# IEEE P802.3da Comment #123 on Mode Conversion

David D. Brandt, Rockwell Automation

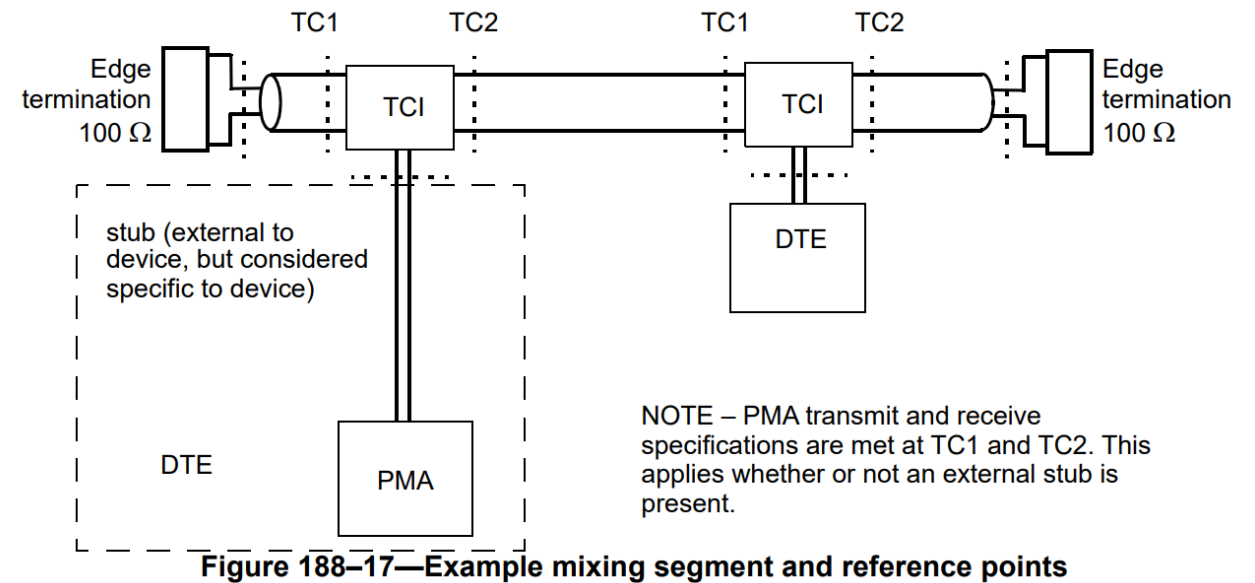
- Clause 147 specifies “where” the specification applies
  - **Impractically large** number of measurements

The mixing segment shall meet the mode conversion loss characteristics specified for link segments in 147.7.3 **between any two MDI attachment points.**

- Clause 188 lacks a “where”
